This Field Safety Notice (FSN) contains important customer information for patient safety and for the safe use of *exoplan*, our software for implant planning and surgical guide design.

Internal exocad Reference: #278955

Field Safety Notice #278955 related to Camlog Sleeve Library

Figure 1: Sketch comparing the distance situation between sleeve, implant and drill for the wrongly positioned sleeve (left) and the correct position of the sleeve (right).

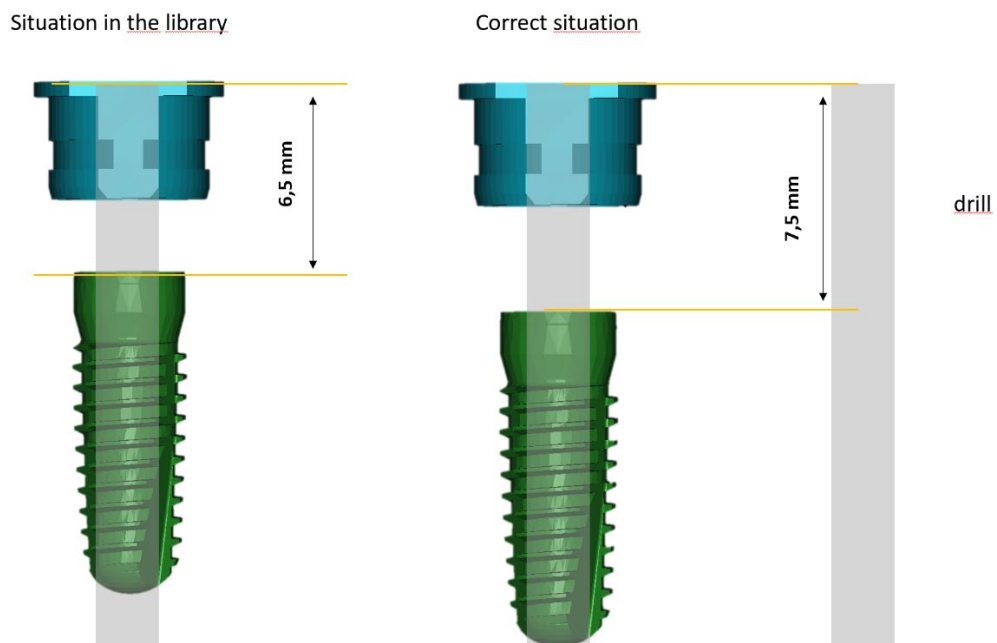
Affected libraries: The issue is an incorrect distance information contained in libraries CAMLOG_sleeve and Steco_StecoGuide_Compatible_Camlog_sleeve suggesting the usage of a surgical sleeve that results in a drill hole that is 1mm deeper than expected due to a dimensional error in the affected libraries.

During an update of data used in a library shipped with *exoplan* or made available on the download portal of *exocad*, it was found that the use of a specific combination of an implant, sleeve and surgical drill can result in a hole being drilled 1 mm deeper than expected.

During surgical alveolar implant preparation and positioning 1 mm lower than planned and expected surrounding anatomical structures can be damaged, including nerves and blood vessels, causing bleeding, paresthesia, and other complications. Over-remodeling of the cervical implant can also occur during the healing process, possibly resulting in bone loss and esthetic concerns. Adhering to pertinent literature*, the recommended safe distance of 2 mm is essential to avoid these risks. Since the literature safety distance of 2 mm is recommended, the library will be within the boundaries limits of the safety distance. By using the above-mentioned library, there is a potential risk of harm to the patient.

- 4) New library versions of CAMLOG_sleeve and Steco_StecoGuide_Compatible_Camlog_sleeve have been released. Users can now download and install the new libraries.

- 1) Do not use the affected libraries - see section “Affected libraries” above.
- 2) Download the new libraries at <https://exocad.com/integration/exoplan-library-integration> or use exocad *Library Manager* from within *exoplan*.

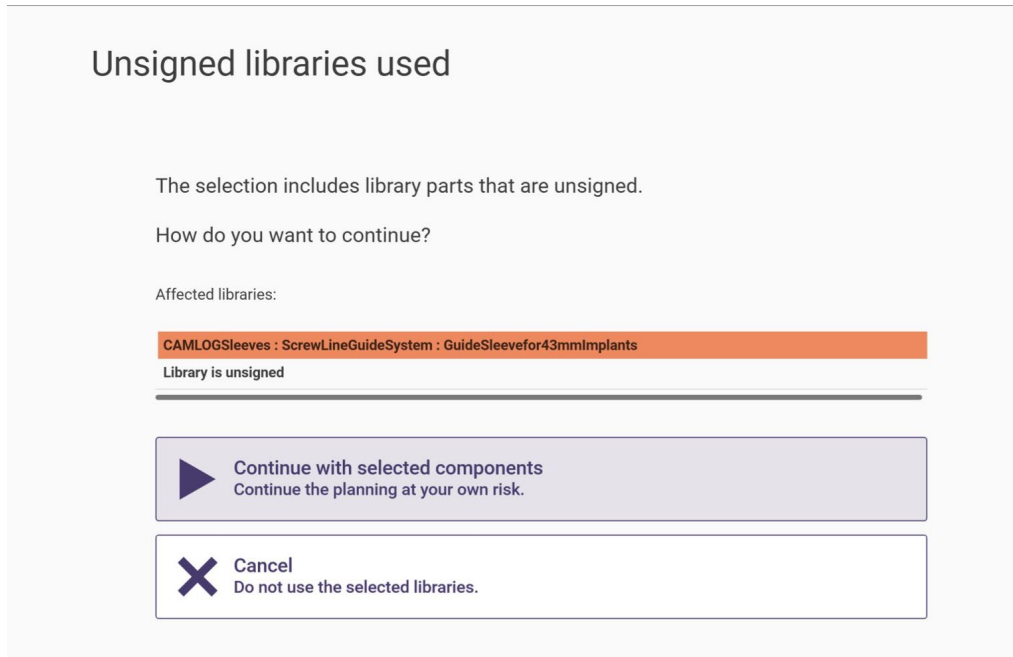
- 2) As a result of the blacklisting, if the user tries to select a component in the affected library, the user receives a message indicating that the selected sleeve library is marked as “unsigned” and should no longer be used. This message appears when the user selects the blacklisted library, as well as before the implant planning and surgical guide output data is generated. Users notified by this warning should click “cancel” and not “continue”. If users click continue, they continue at their own risk.

Figure 3: Unsigned library message of a blacklisted CAMLOG® / StecoGuide library to the user when loading a scene file that already contains the affected library.

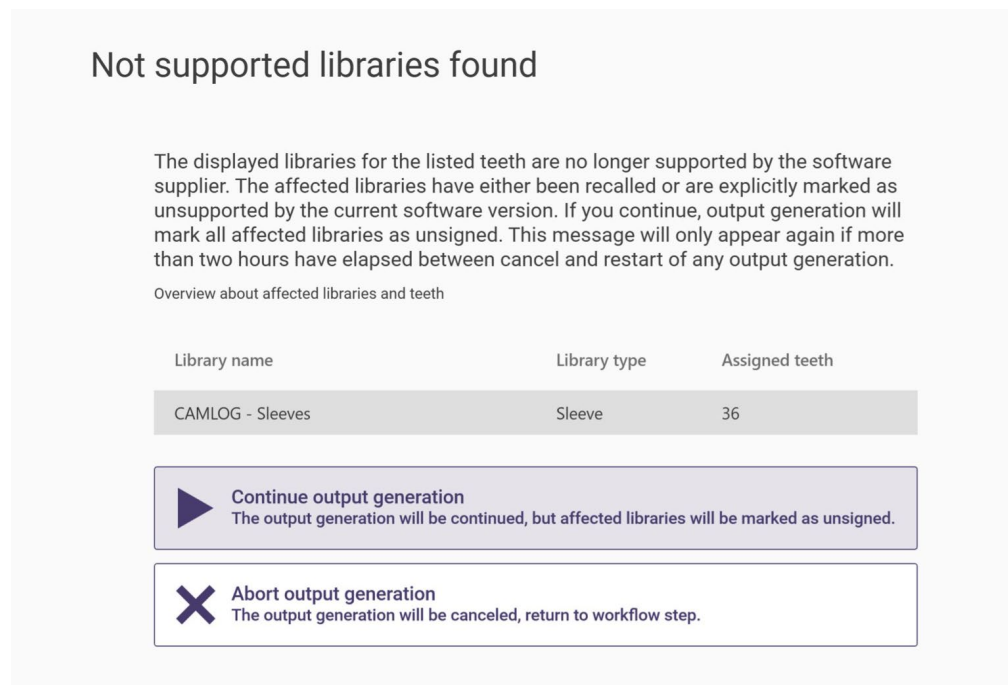
- 3) If an implant planning “scene file” (file containing all the information about a planning or design scene, e.g., workflow state, scene objects) is loaded into *exoplan* that previously used the blacklisted sleeve library in the implant placement planning, a warning message appears to inform the user about the unsigned library (see figure 3).
